## KEY STREET COMMERCIAL PARK SUBDIVISION

APPLICATION N	UMBER_	16	DATE _	April 1, 2004	N
APPLICANT Key Street Commercial Park Subdivision					Å
REQUEST Subdivision					1
					NTS

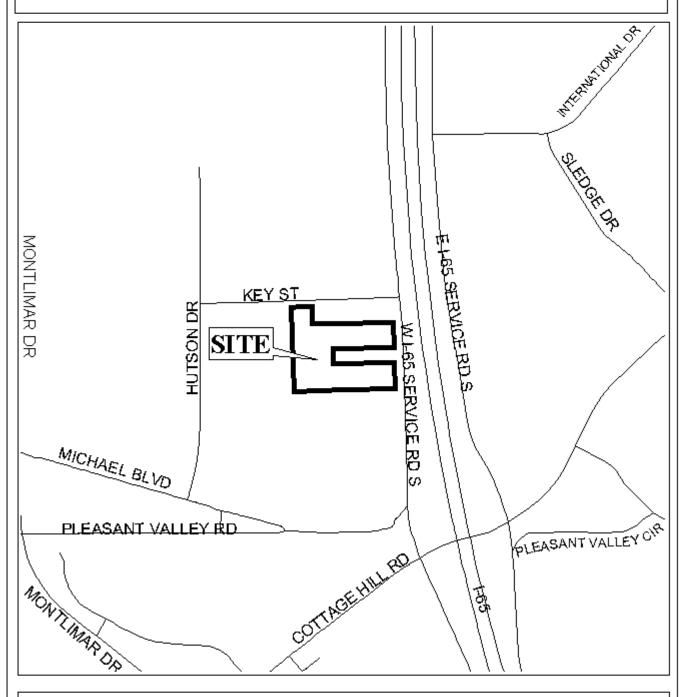
The site fronts West I-65 Service Road South, a planned major street as illustrated on the Major Street Plan and has an existing right-of-way in compliance with the Plan. However, as a means of access management, the placement of a note on the final plat stating that Lots 1 and 4 are limited to one curb cut each to the Service Road, and Lots 2 and 3 are limited to one curb cut each to Key Street, with the location, size, and design to be approved by Traffic Engineering, should be required.

The 25-foot minimum building setback lines are not shown but would be required on the final plat.

The plat meets the minimum requirements of the Subdivision Regulations and is recommended for Tentative Approval subject to the following conditions: 1) the placement of a note on the final plat stating that Lots 1 and 4 are limited to one curb cut each to the Service Road, and Lots 2 and 3 are limited to one curb cut each to Key Street, with the location, size, and design to be approved by Traffic Engineering; and 2) the placement of the 25-foot minimum setback lines on the final plat.
